ADDENDUM TO THE CONTRACT

F STREET RECONSTRUCTION Contract No. BE17-215

ADDENDUM NO.: ONE

DATE ADDENDUM ISSUED: July 26, 2017

F STREET RECONSTRUCTION
CONTRACT NO. BE17-215
HEADWALL DETAIL
ADDENDUM NO. ONE

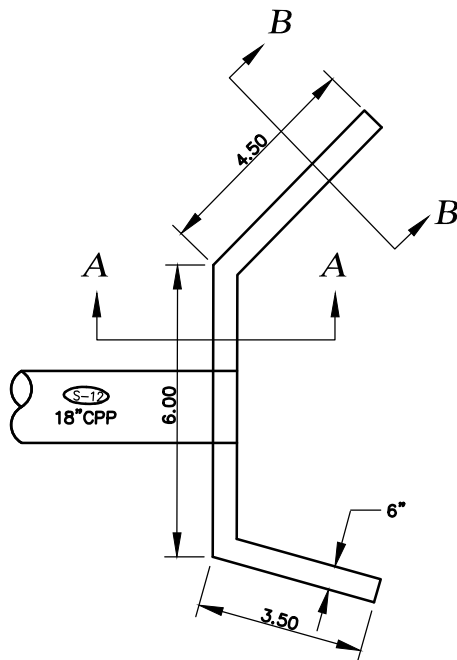
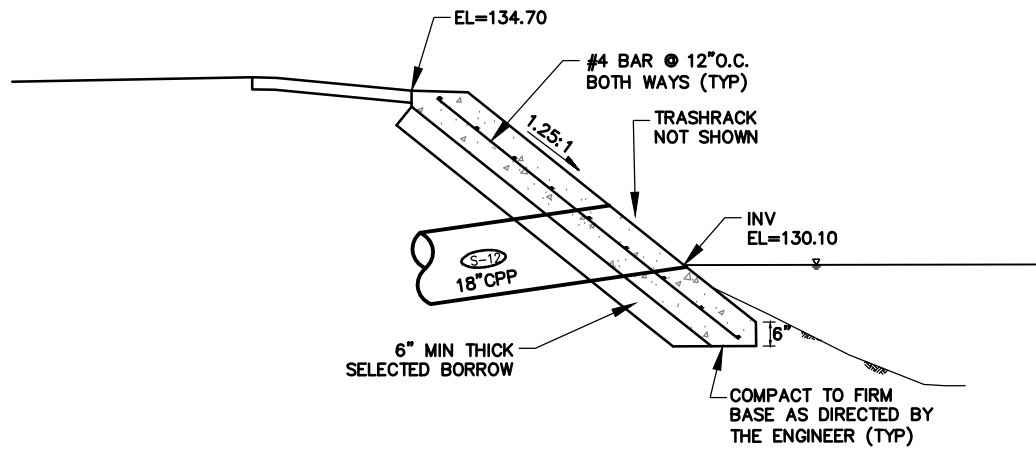
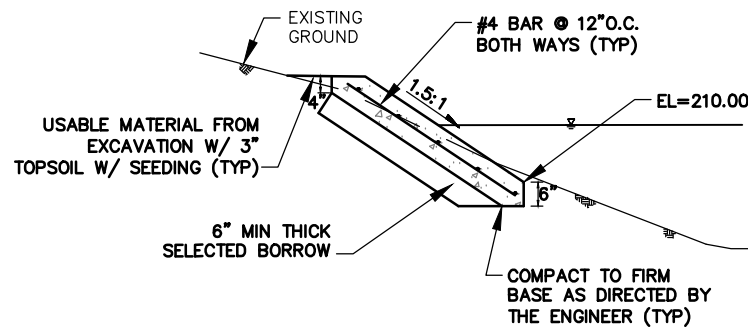
Item No. 9: Sheet 9 of 9. **Add** the attached Headwall Detail, labeled Addendum No. 1.

SHEET:
7A of 9

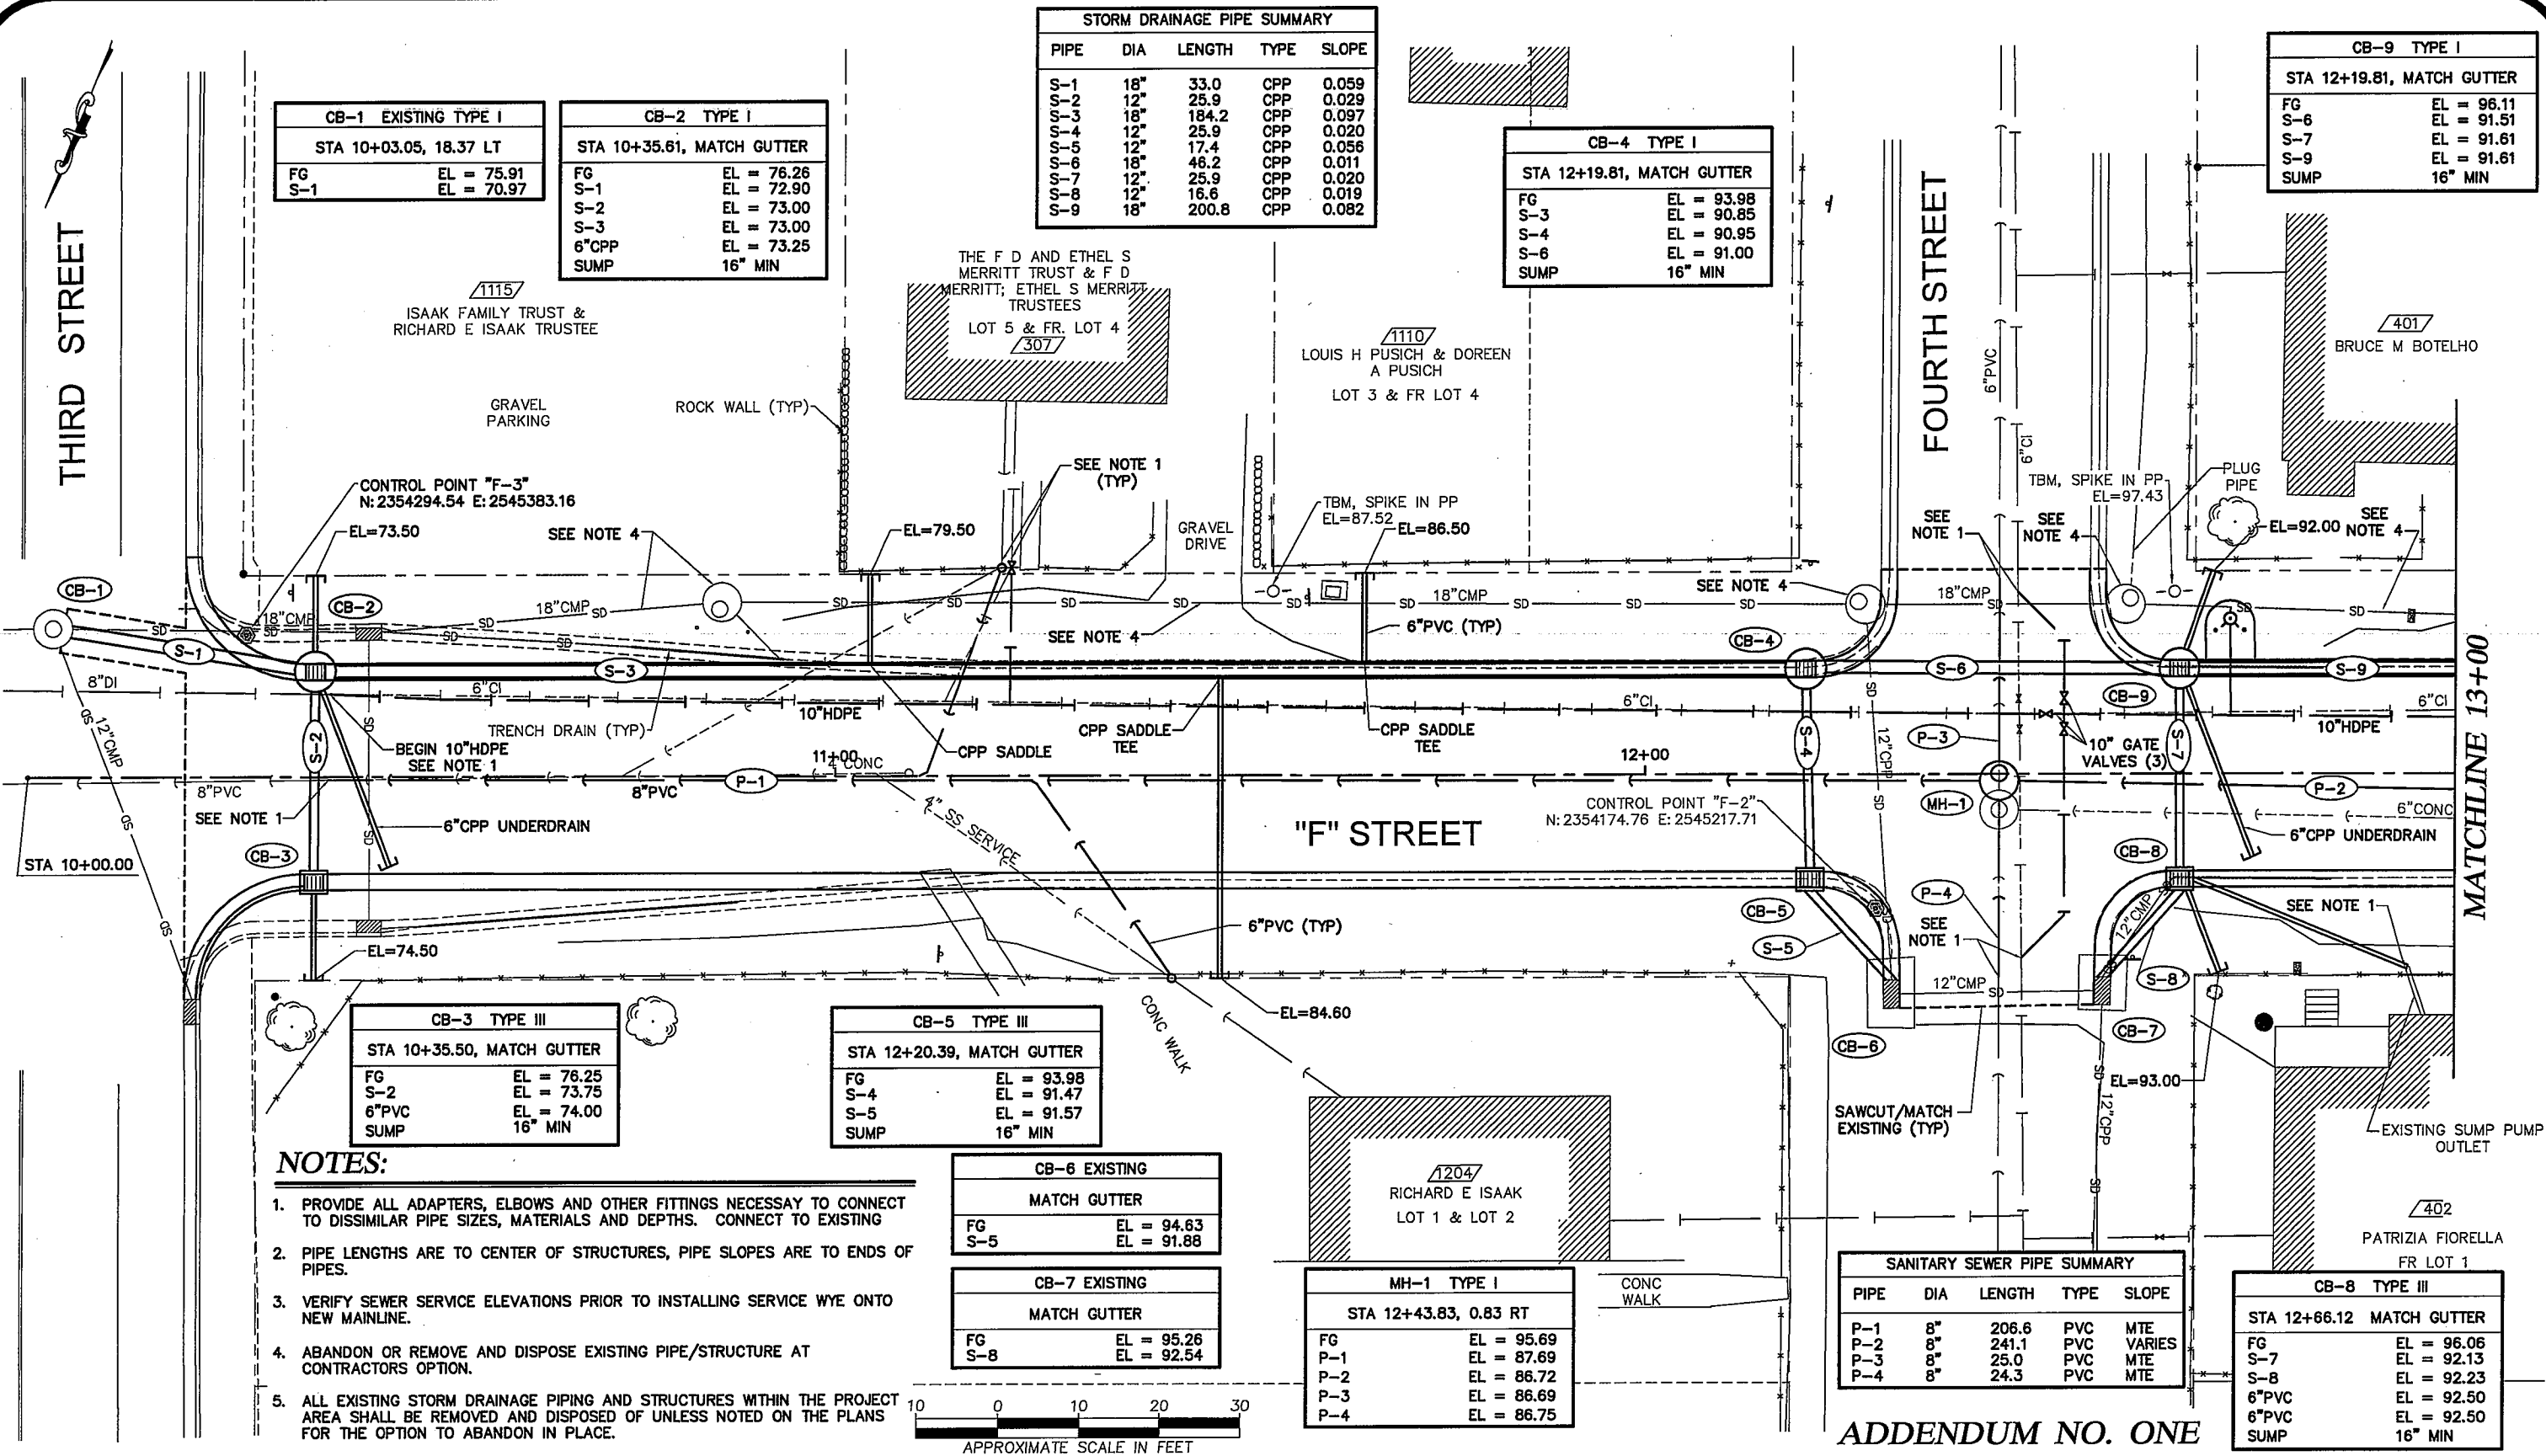
Item No. 8: Sheet 7 of 9. **Delete** in its entirety, and **replace** with the attached Sheet 7A of 9.
